Belvac Production Machinery Technical Bulletin

ISSUE 6, VOLUME 12, JUNE 2009

CC93/CC95 Trimmer Rotary Union Replacement

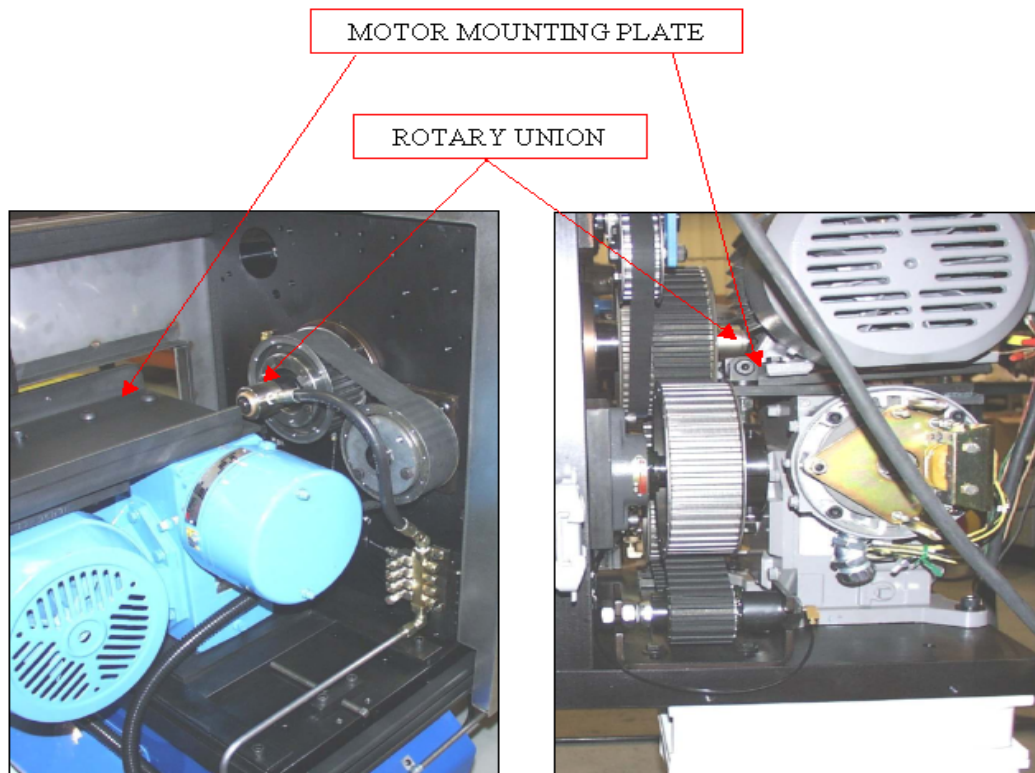
Belvac had used Talco Rotary Union C30405 for many years on all our CC trimmer series. Due to recent quality issues with the Talco unit that could not be resolved to our high standards, Belvac partnered with Rotary Systems to develop a unique and robust rotary union specific to Belvac's application. A Carbon Steel Construction with Hardened Shaft, Dual Sealed ball bearings, and Teflon seals make the new rotary union distinctive and durable. It has been successfully tested and implemented on all new Belvac CC Trimmers since April 2008. The new union has a new Belvac part number **C10123** and is a direct replacement to the Talco on the shaft.

The new rotary union has a slightly larger body size than the part it replaces. Please note when installing for the first time, it is possible that the motor mounting plate requires a small cut-out to allow clearance of the new rotary union. (See pictures below). Belvac no longer supplies the Talco rotary union (Belvac part number C30405). If the C30405 part number is ordered, you will automatically receive the new rotary union part number **C10123**.
